## For Thursday meeting

PLAN:  
2ND FLOOR  
BATH 2  
BATH 3

PHIL & MICHELLE WOOD  
3435 N. 140TH. CIRCLE  
OMAHA, NE 68164

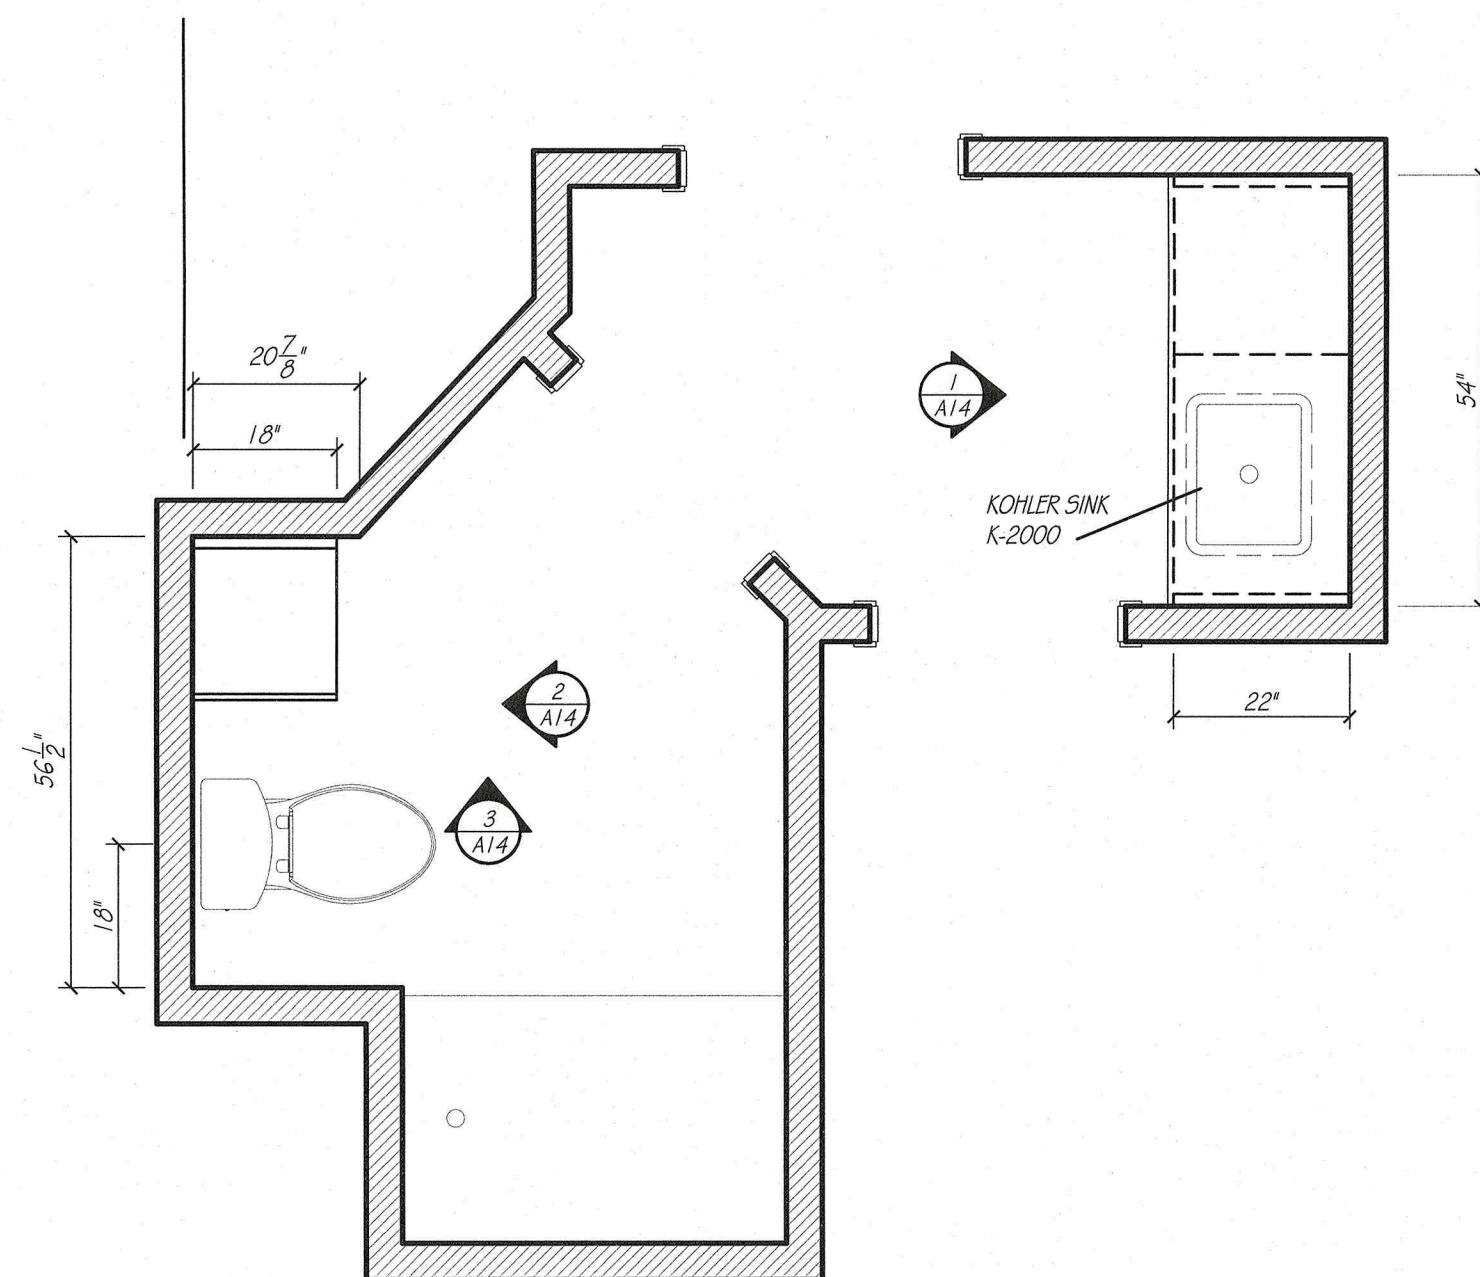
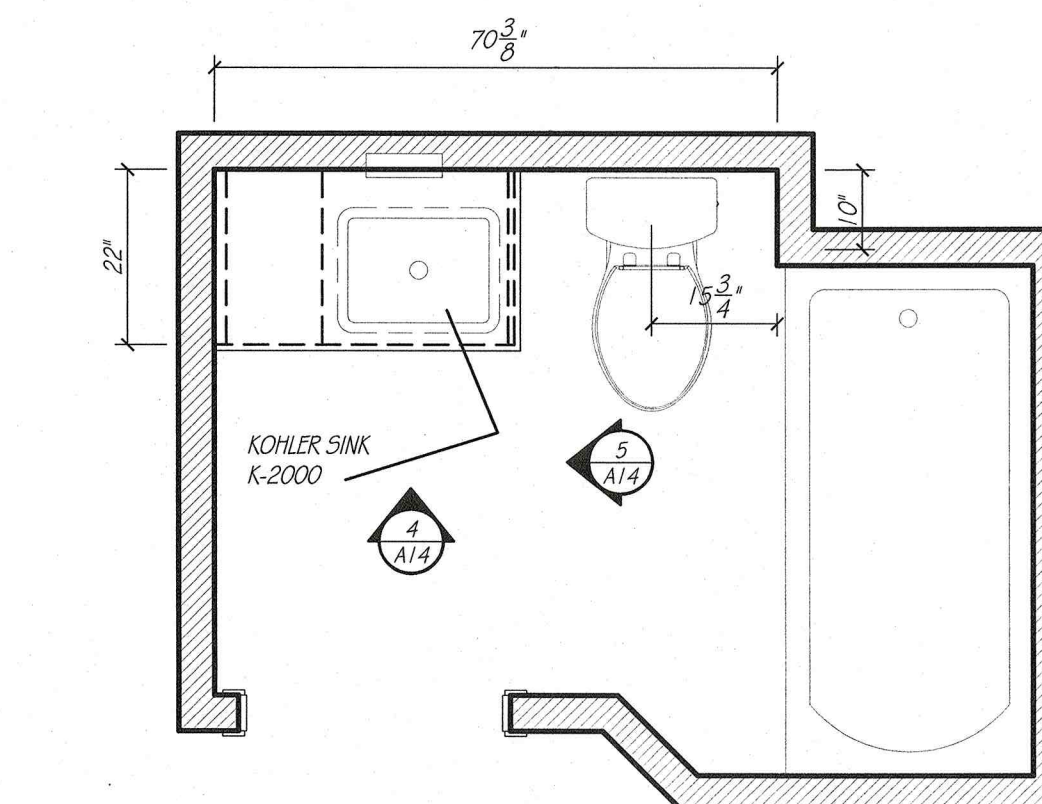
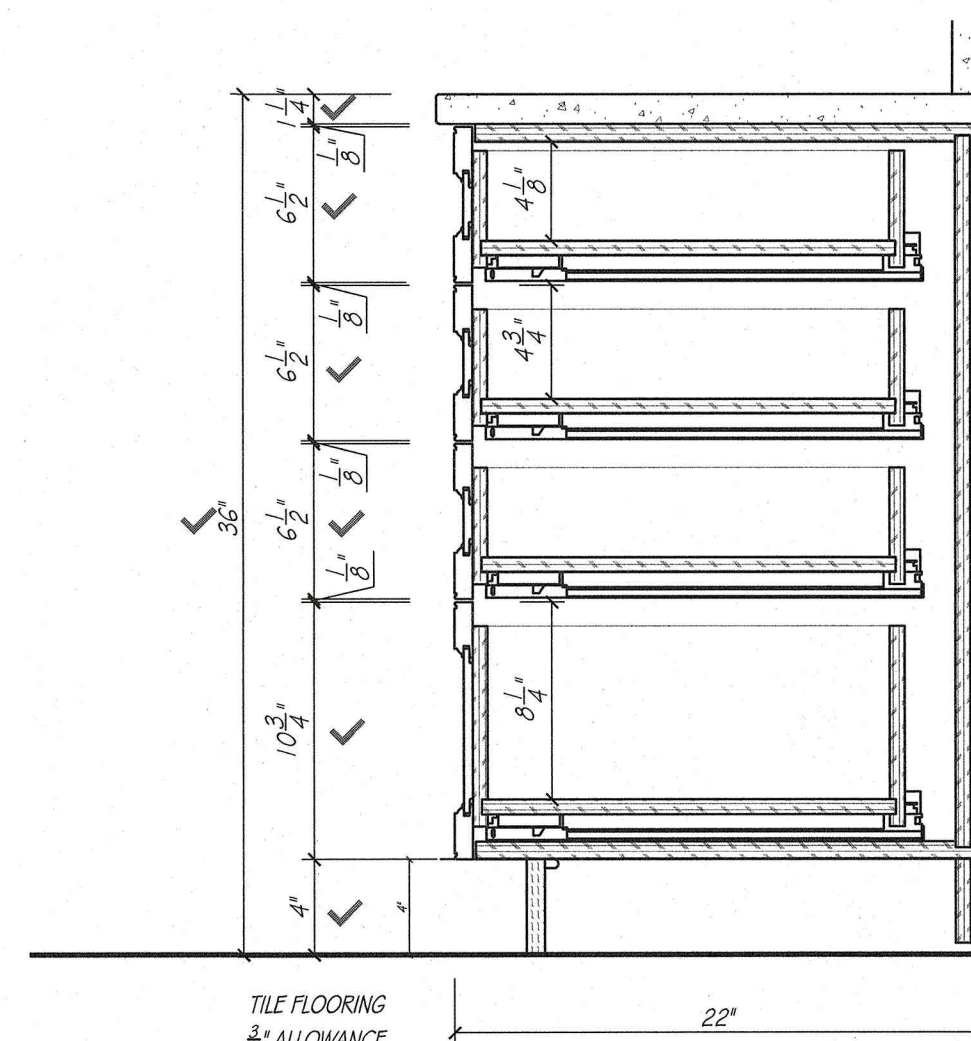
EW OGEE with SCOOPED OUT TOEKICK (match Bath 3)

confirm with Wood's - match profile of crown in bathroom or go with the simpler cove profile at Bath 2 Linen? - confirmed to match crown in bathroom  
MATCH BATH CROWN EXISTING = CONFIRMED
